NORTH CAROLINA DIVISION OF AIR QUALITY			Region: Washington Regional Office County: Bertie NC Facility ID: 0800102 Inspector's Name: Mike Smithwick Date of Last Inspection: 11/08/2010 Compliance Code: 3 / Compliance - inspection
Air Permit Review – Renewal			
Permit Issue Date: January XX, 2012			
Facility Data			Permit Applicability (this application only)
Applicant (Facility's Name): Eastern Carolina Regional Solid Waste Landfill			SIP: 15A NCAC 2Q .0513 NSPS: Subpart WWW (revised gas collection and control system design plan with alternate monitoring, recordkeeping, reporting, and operational requirements)
Facility Address: East Carolina Regional Solid Waste Landfill 1922 Republican Road Aulander, NC 27805			NESHAP: N/A PSD: N/A PSD Avoidance: N/A NC Toxics: N/A 112(r): N/A Other: N/A
SIC: 4953 / Refuse Systems NAICS: 562212 / Solid Waste Landfill			
Facility Classification: Before: Title V After: Title V Fee Classification: Before: Title V After: Title V

The consulting firm SCS Engineers, P.C. submitted the information for this application on behalf of the Eastern Carolina Landfill. Application No. 0800102.10A was received by the Division of Air Quality Raleigh Central Office

Diagram 1

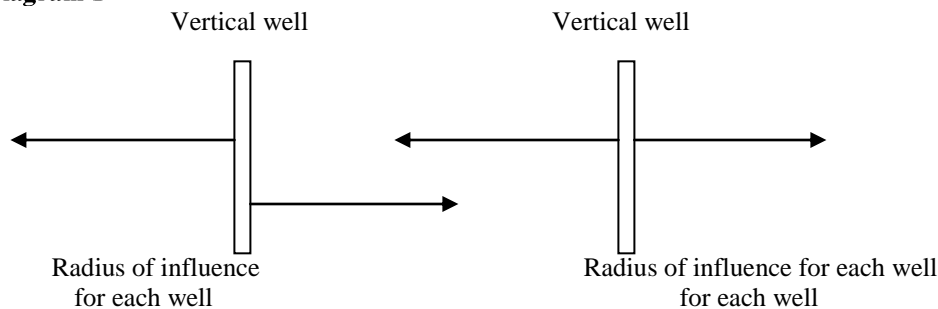
With a Radius of Influence of 248 feet, gas wells will theoretically collect gas from an area of about 4 acres in size. When the gas system designer plots the well locations on a landfill's topographic map and draws the calculated Radius of Influence around each well, it is desirable to achieve a certain degree of overlap of the circular Radius' of Influence. This will reduce the design collection area of each well. Final well densities usually are about 2 acres per well for most landfills. Since the calculations are theoretical to begin with, the overlap provides a factor of safety to the gas control system design.

Diagram 2 Typical Vertical Extraction Well

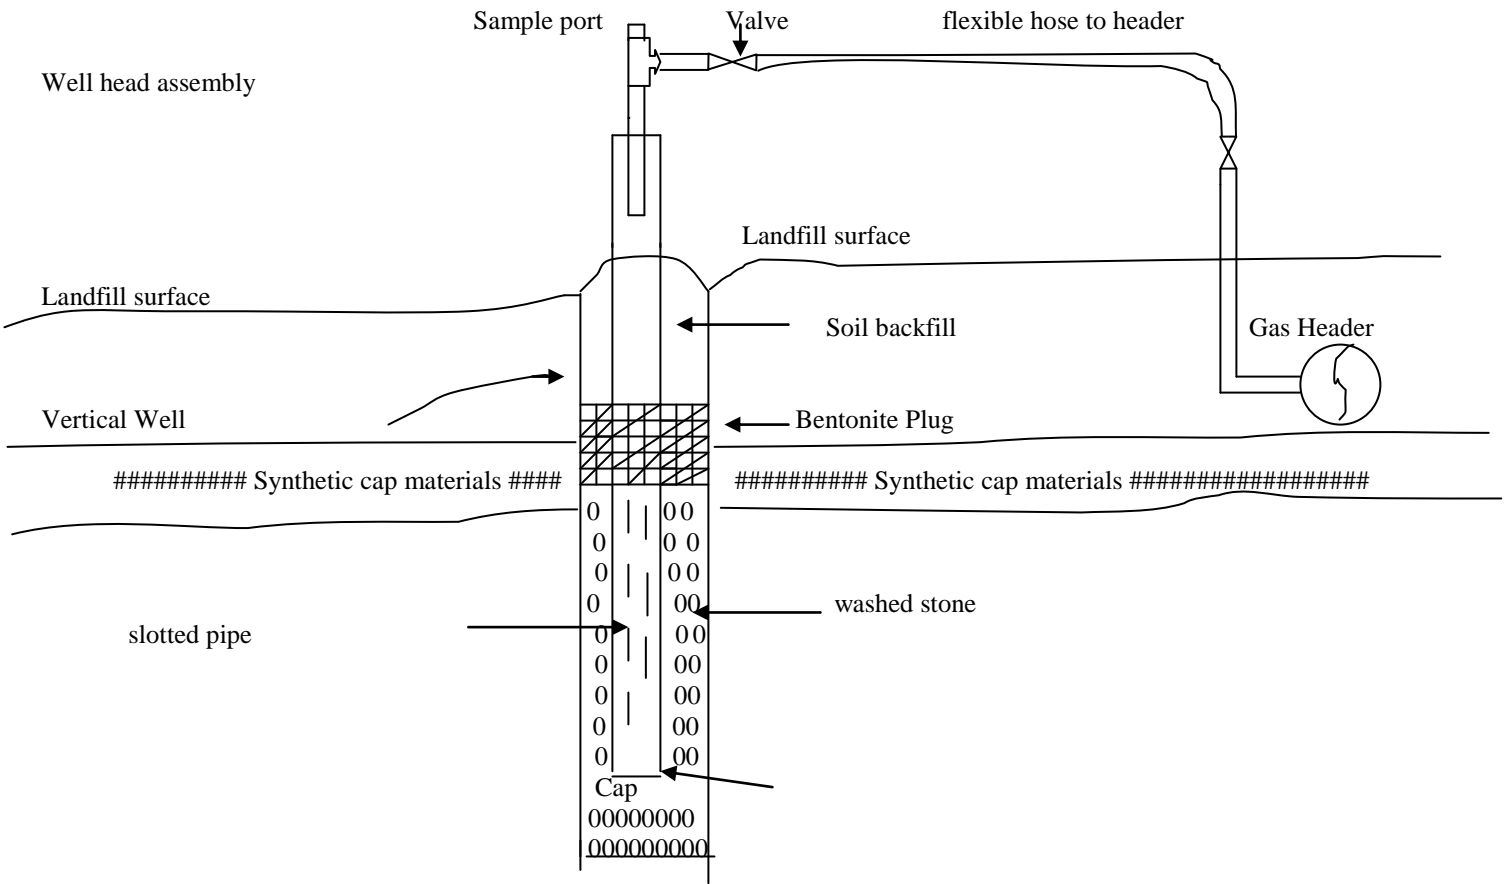
5. Wellheads:
Each well will be equipped with a wellhead assembly that will include: a valve for adjusting pressure and flow, a flow measuring device (pitot tube or orifice plate), and sampling ports for monitoring available vacuum, applied vacuum and temperature. By controlling the applied vacuum at each well through wellhead valves, the monitoring personnel will be able to optimize the quality of the landfill gas and minimize air intrusion into the system. The wellhead assembly will be connected to the collection piping via a flexible hose. The flex hose will be long enough to allow some settlement of the landfill to occur without breaking the connection between the well and the collection piping. Diagram 2 of this review shows a typical vertical well assembly.

Compliance is indicated.
